Memorandum

Subject: Revision of Paper hess-2018-181

Upon your recommendation, we have carefully revised Paper hess-2018-181 entitled “Reactive Transport with Wellbore Storages in a Single-Well Push-Pull Test” after considering all the comments made by the reviewers. The following is the point-point response to all the comments.

Reactive Transport with Wellbore Storages in a Single-Well Push-Pull Test

Figure 2. Comparison of BTCs between the solutions of Wang et al. (2017) and of this study, where C_0^{inj} represents the concentration of the prepared solute in the injection phase.

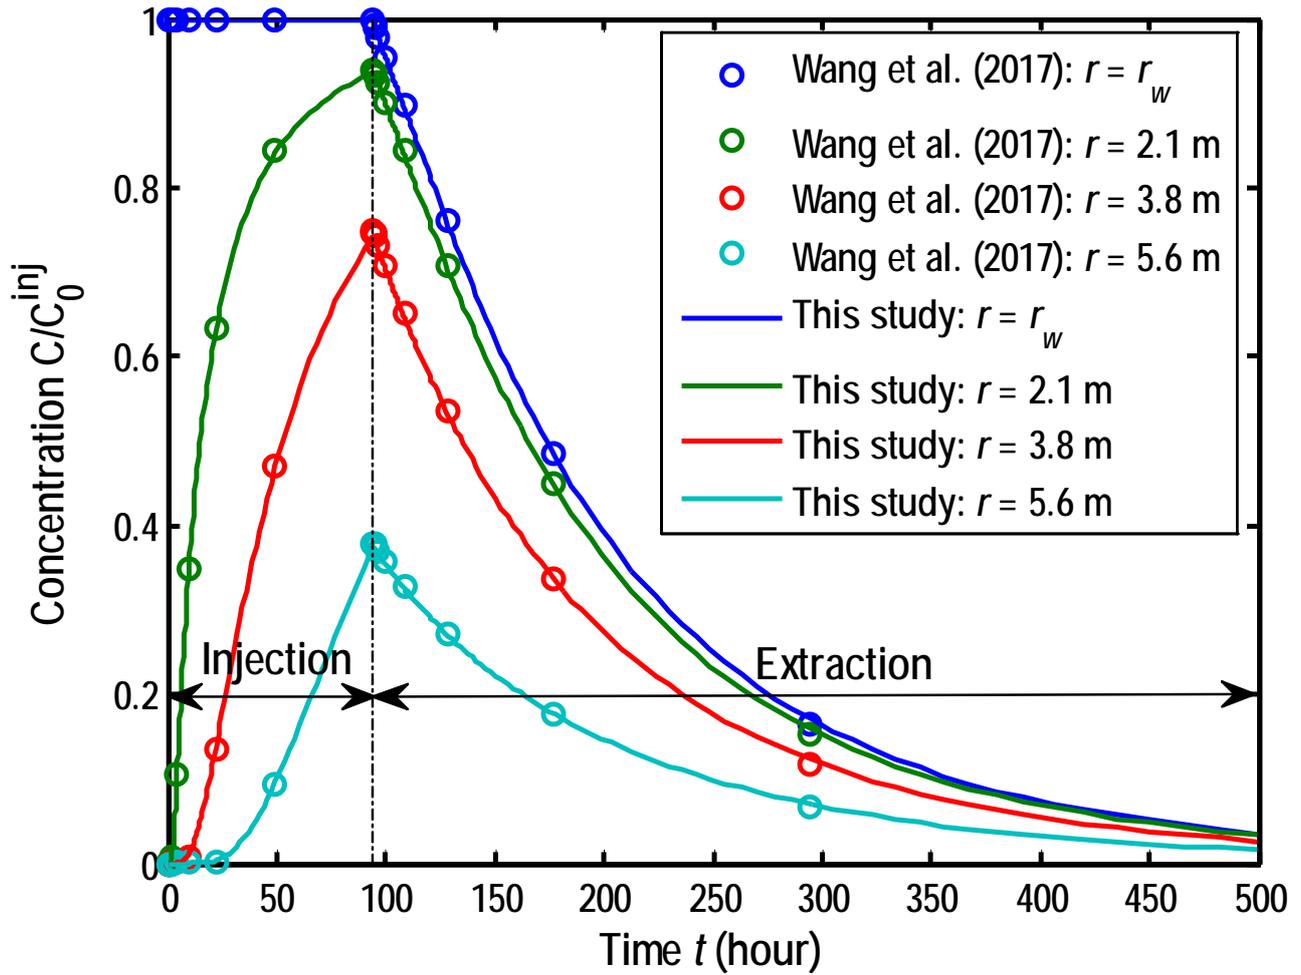
5. Page 18 – Figure 2: How do you explain the small oscillation in your solution?

Reply: Implemented. It shows a small oscillation in the numerical solutions, which might be caused by the numerical errors (See P9 Line 21).

Figure 3. Comparison of BTCs between the solutions of MODFLOW/MT3DMS and of this study.

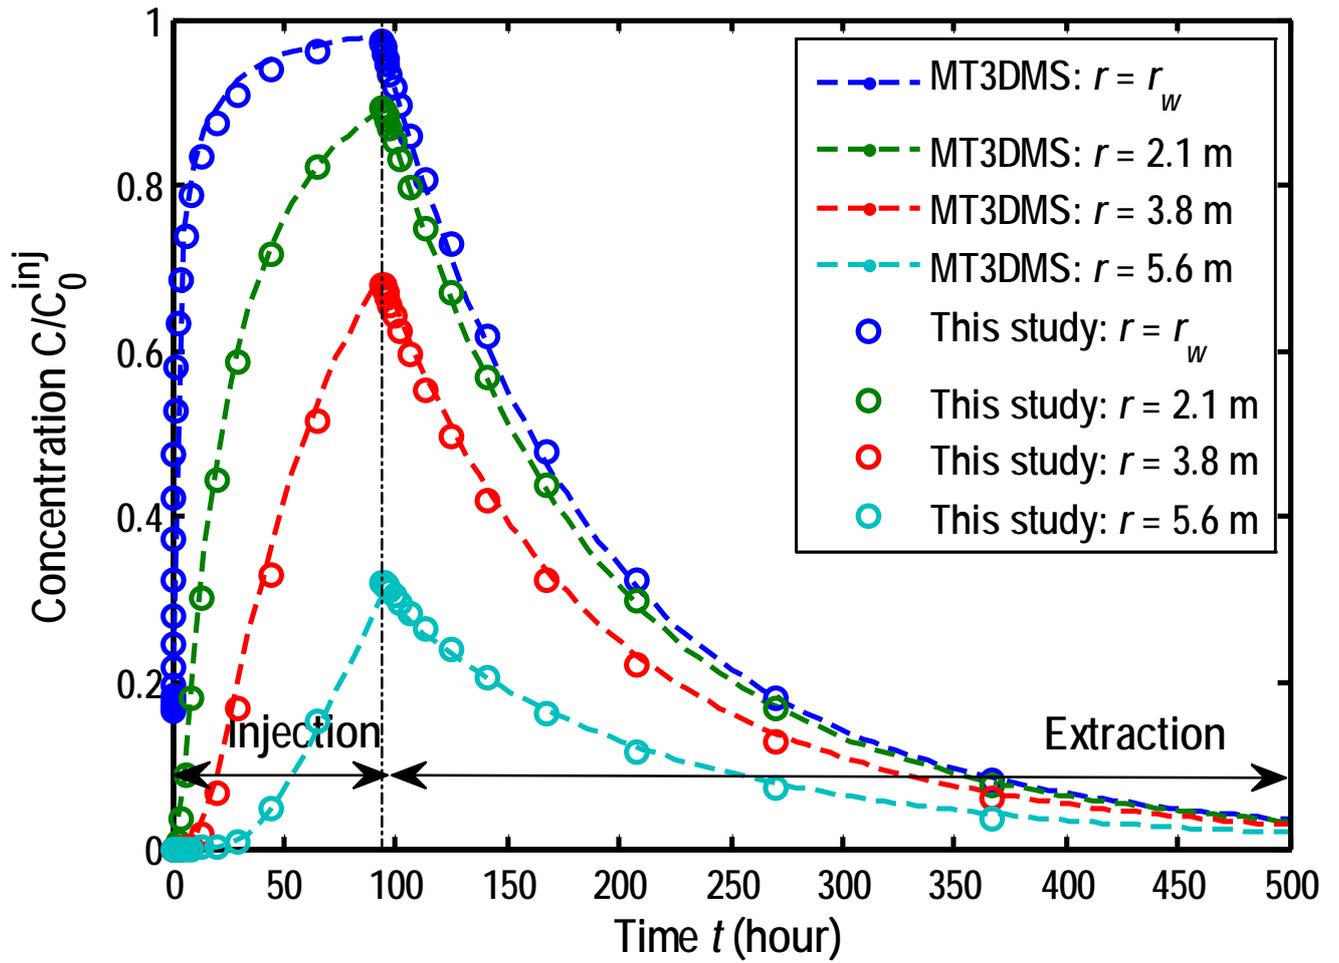
1. The authors presented a study to extend the Phanikumar and McGuire (2010) model for the single-well push-pull (SWPP) tests in homogeneous, isotropic aquifers by replacing the oversimplified boundary conditions with more complex conditions to account for wellbore storage effect (the Model). The Phanikumar and McGuire (2010) model is a polar coordinate mathematical model used to interpret SWPP tests involving multi-species reactive transport problems with non-linear reactions. The aim of the study was to reduce the potential errors that may be introduced by ignoring the storage effect in the previous models. The authors verified the accuracy of the Model by comparing the breakthrough curves (BTCs) modeled by the proposed mode with those generated by the Wang et al. (2017) model. The Wang et al. (2017) model is a similar expansion the Phanikumar and McGuire (2010) model accounting for wellbore storage with respect to groundwater flow. The difference is that the Model accounts for wellbore effects with respect to solute concentration, in addition to flow. Lastly, the authors used the Model to interpret the breakthrough curves (BTCs) of a SWPP field test reported by McGuire et al. (2002) and compared with interpretation of the same BTCs by the Phanikumar and McGuire (2010) model. I have no issues with how the wellbore boundary conditions are formulated. However, I have concerns on the approach the authors taken to verify the Model, which may cast doubts on the practical usefulness of the Model,

Reply: Implemented. We have verified the model of this study using MODFLOW/MT3DMS (See Figure 3, and P10 Lines 3-13).

Figure 8. Comparison of BTCs for different dispersivities and porosities but for the same hydraulic parameters.

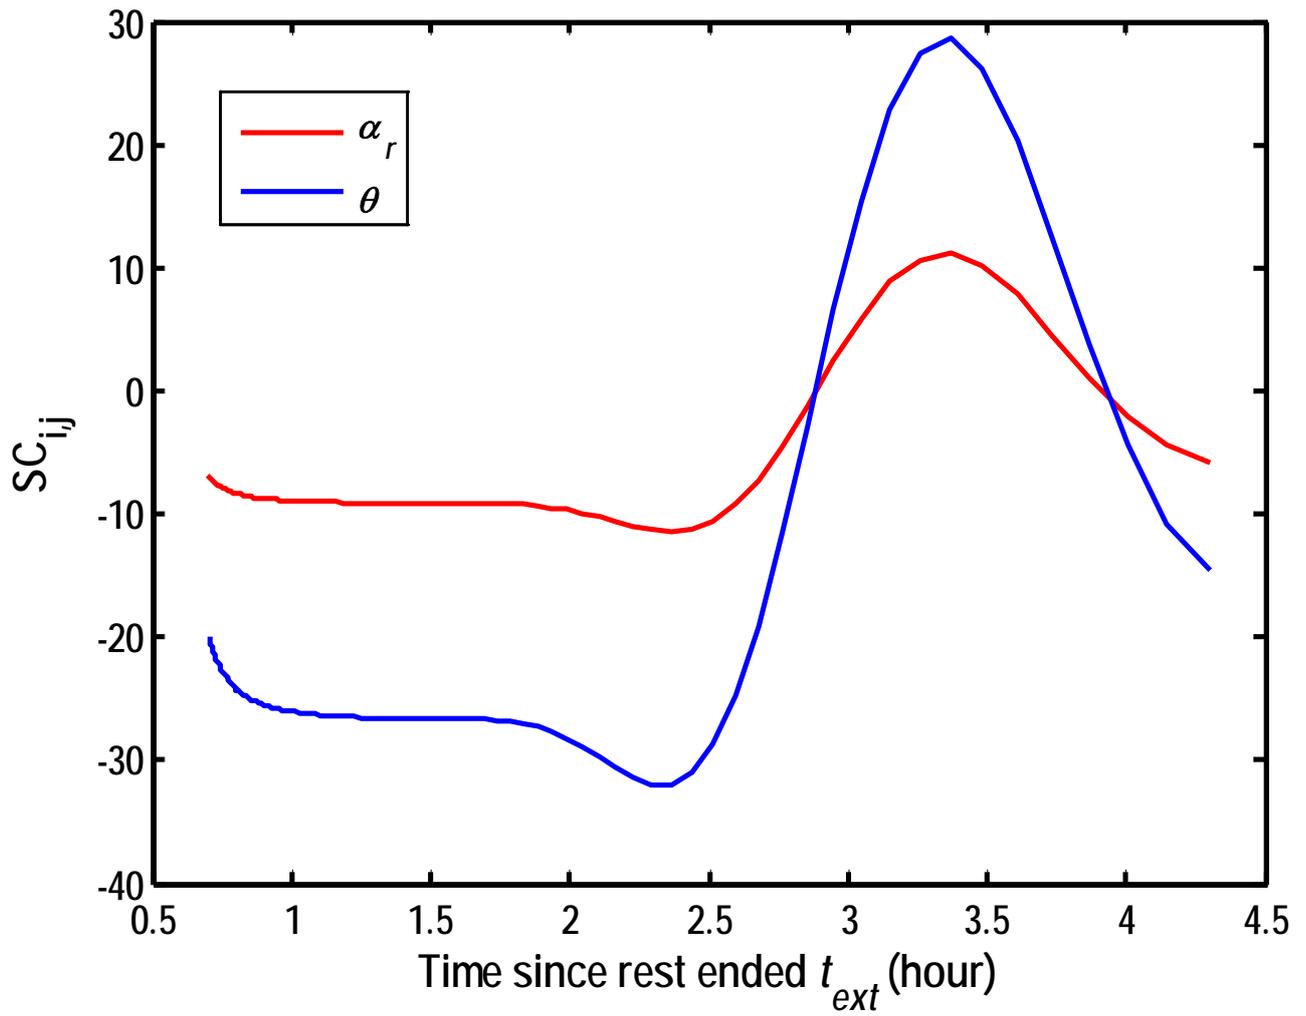
Response to the uniqueness of estimated parameters: When both dispersivity and porosity are unknown, the solutions are non-unique, as shown in Figure 8. However, when the porosity is given in advance, the estimation of dispersivity is unique (See P14 Lines 1-5). In this study, we mainly estimated the value of dispersivity, where the porosity is fixed and comes from the reference of Phanikumar and McGuire (2010). Therefore, the dispersivity is uniquely determined (See P17 Lines 8-10).

A
Figure 12. BTCs for the different porous media with a piecewise linear function to describe chemical reactions: A. Cl^- and SO_4^{2-} in the aquifer at $r = r_w + 0.15$ m, B. Cl^- in the wellbore.

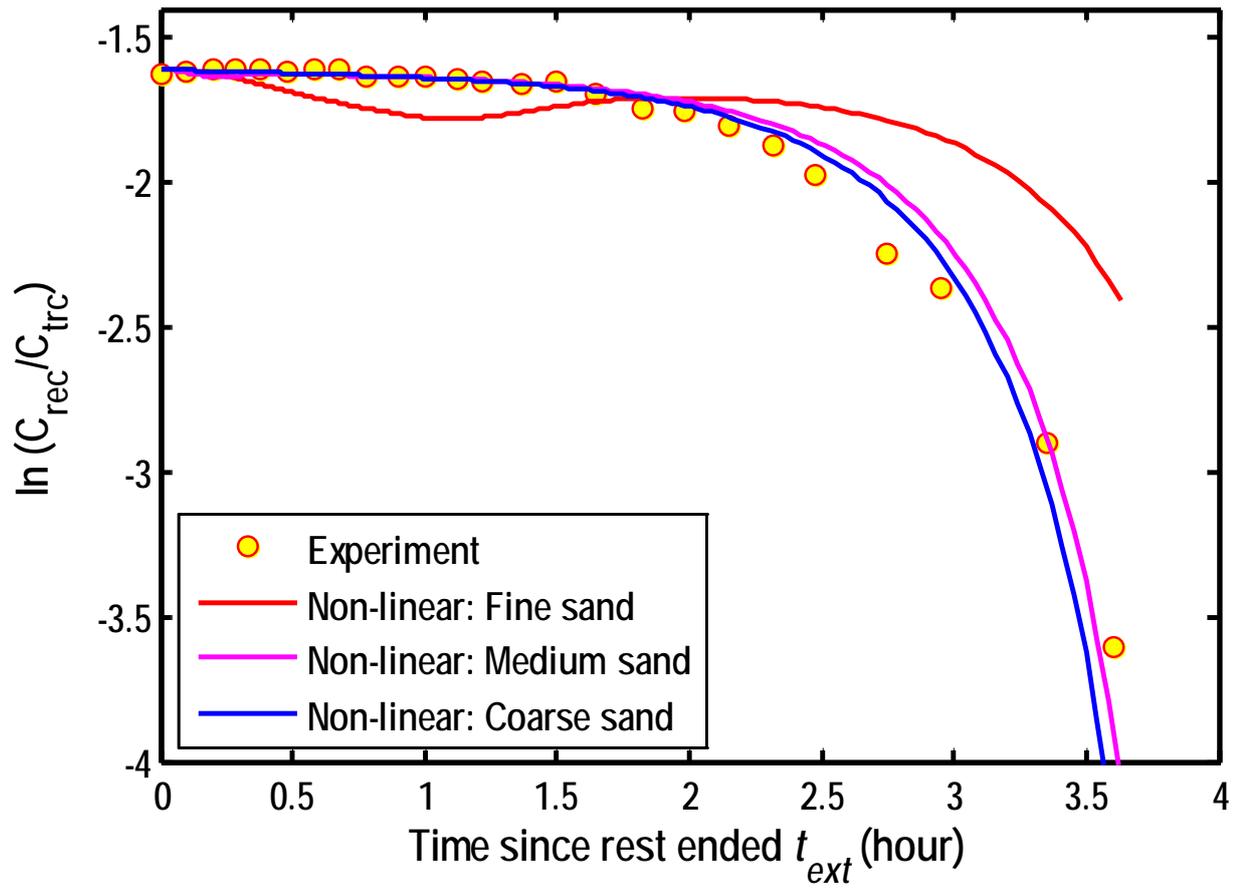
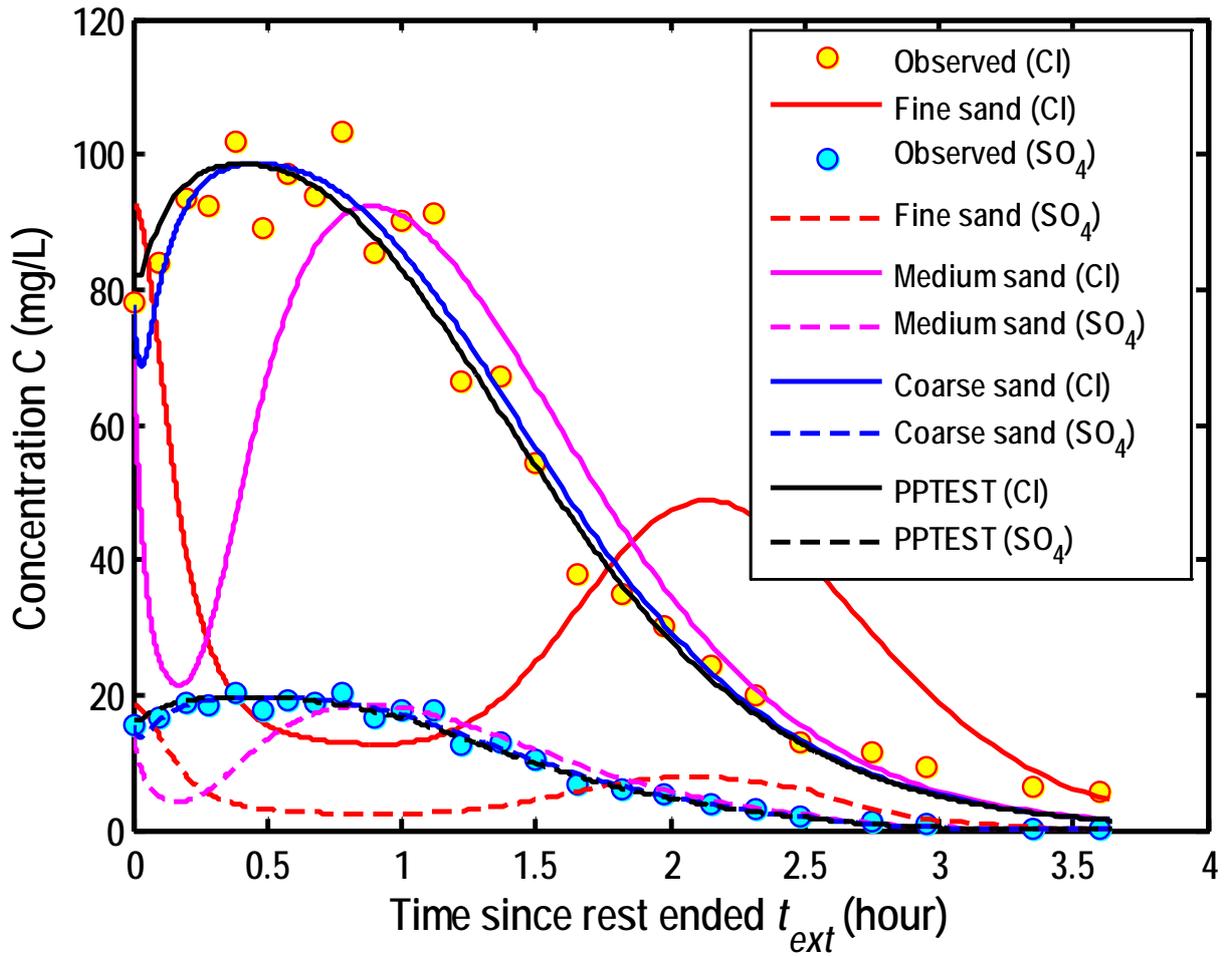
6. Page 28 – Figure 10: Please add the interpretation of Phanikumar and McGuire (2010) for comparison. Technical corrections

Reply: Implemented. The observed and computed BTCs by Phanikumar and McGuire (2010) are added in Figures 12A and 12B for comparison (See Figures 12A and 12B).

Figure 13. Spatial distribution of the flow velocity in the extraction phase.

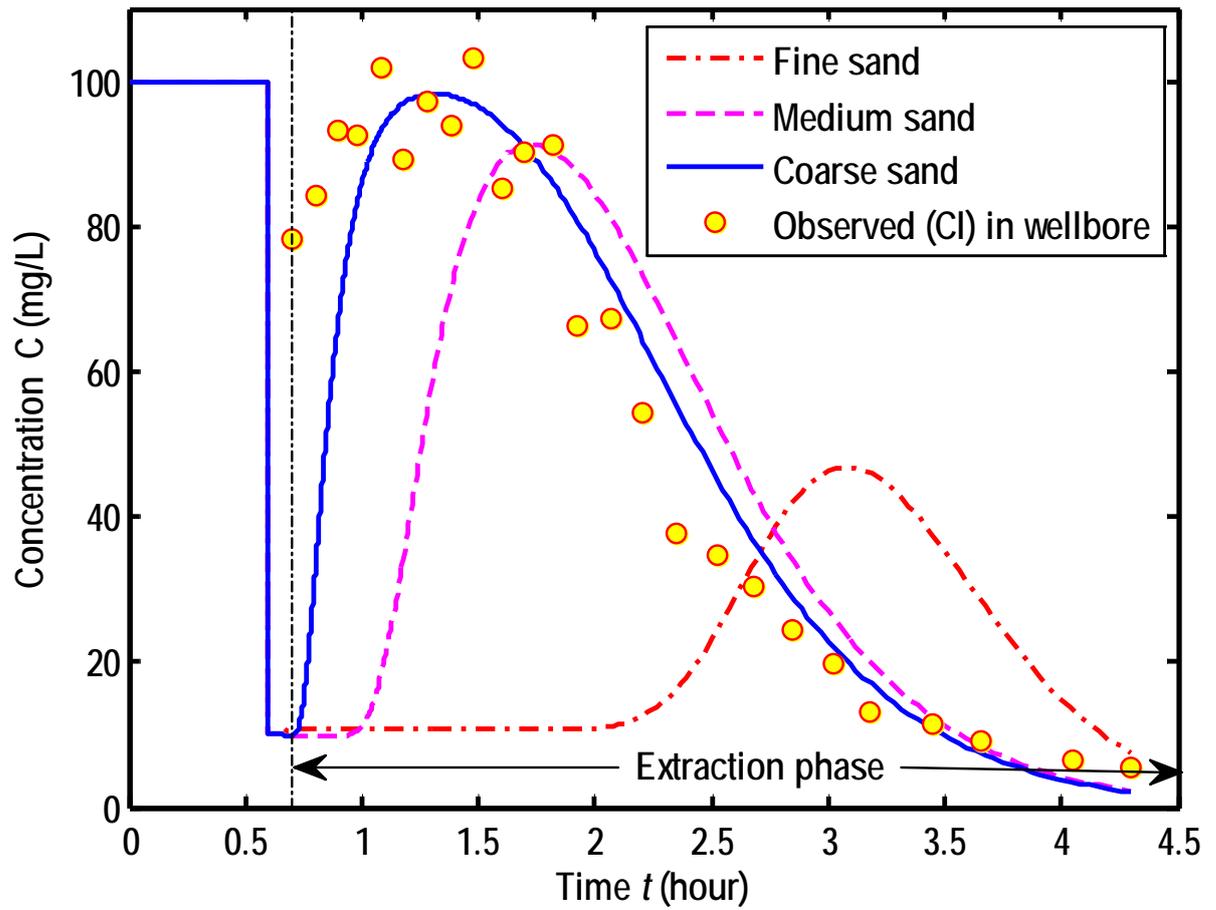
15. Page 27 – Figure 9: Flow velocity is written using q_r while it should be v_r .

Reply: Revised (See Figure 13).
